Parking Brake Adjustment / Calibration Difficult or Not Possible

Vehicles Affected

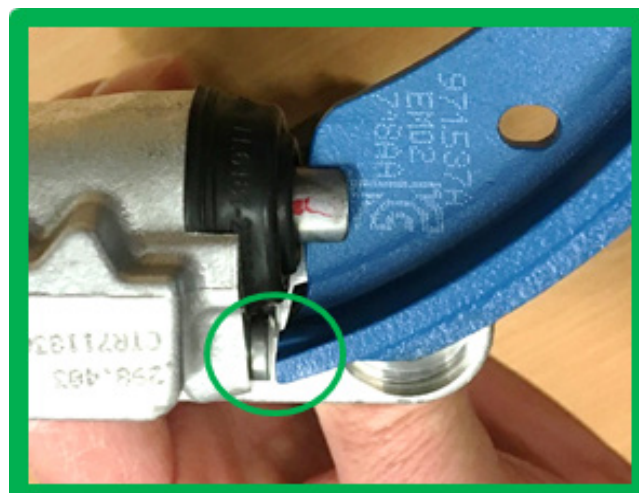
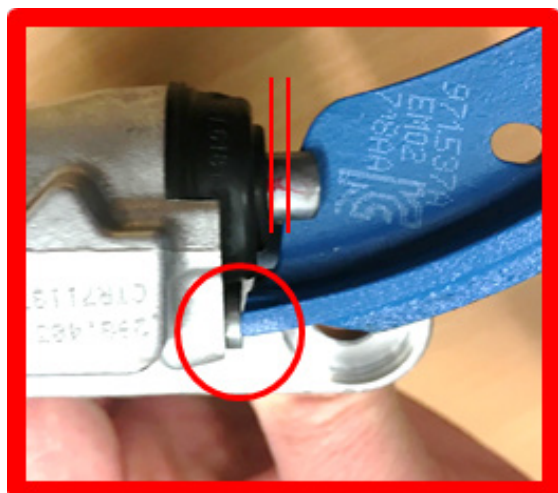
Parking brake shoes were manufactured that were too long on one end. This resulted in not enough clearance for the shoe. A visible gap will exist with the new improved shoe, as seen in the photo on the right.

Replace the parking brake shoes with new shoes, Part Number 971.698.533.C
Parts stock was purged earlier last year. All parts in stock are known good parts.
